Rq 1

How to read it

What does the cointegration test mean?

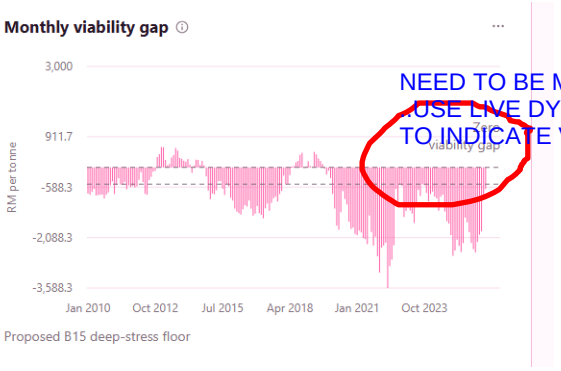
I TOT COINTEGRATION SHUD USE SAME VARIABLES AS THE PME COST FUNCTION

,,N JST EXPLAIN THE PURPOSE OF COINT TST ,,,N HOW IT AFECT THE PME COST VALIDITY FUNCTION

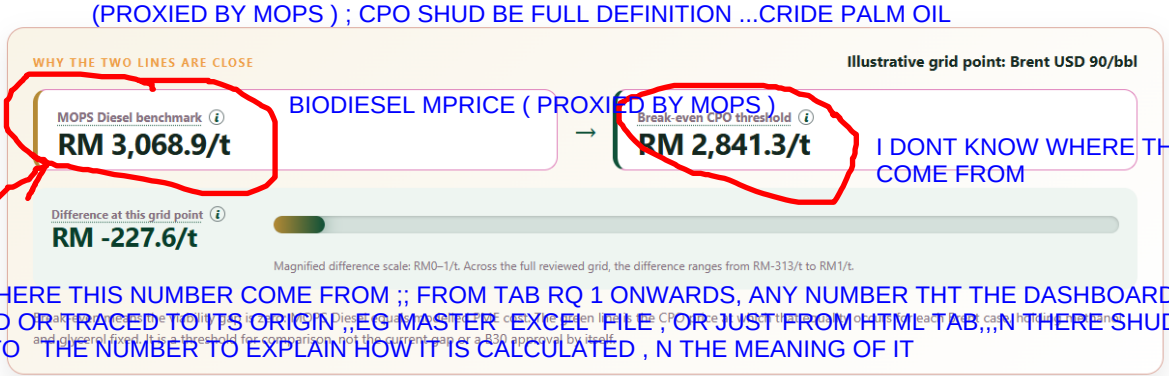
NEED TO BE MORE CKLEAR USE LIVE DYNAMC ARROW TO INDICATE VG =0

USE COSISTENT TERM

: PME SHUD BE BIODIOSEL PRICE (MOPS PROXIED); DIESEL MOPS DIEEL SHUD BE DIESEL PRICE (PROXIED BY MOPS) ; CPO SHUD BE FULL DEFINITION ...CRIDE PALM OIL

BIODIESEL MPRICE (PROXIED BY MOPS)

I DONT KNOW WHERE THUIS NUMBER COME FROM

I DONT KNOW WHERE THIS NUMBER COME FROM ;; FROM TAB RQ 1 ONWARDS, ANY NUMBER THT THE DASHBOARD PRODUCE SHU BE HYPERLINKED OR TRACED TO ITS ORIGIN ,,EG MASTER EXCEL FILE , OR JUST FROM HTML TAB,,,N THERE SHUD BE A FLOATING ICON DYNAMIC TO THE NUMBER TO EXPLAIN HOW IT IS CALCULATED , N THE MEANING OF IT

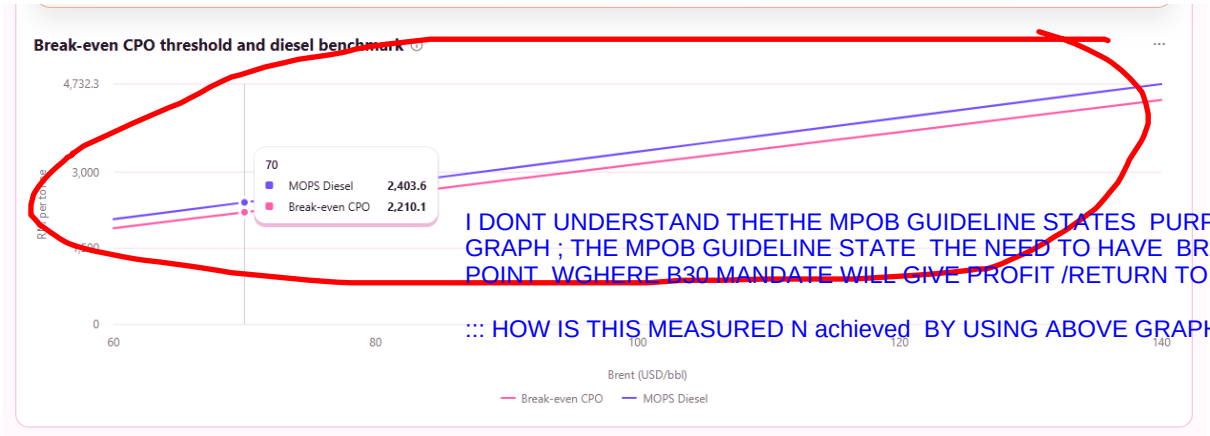
I DONT UNDERSTAND THETHE MPOB GUIDELINE STATES PURPOSE OF THIS GRAPH ; THE MPOB GUIDELINE STATE THE NEED TO HAVE BREAK EVEN POINT WGHERE B30 MANDATE WILL GIVE PROFIT /RETURN TO COUNTRY

::: HOW IS THIS MEASURED N achieved BY USING ABOVE GRAPH ?
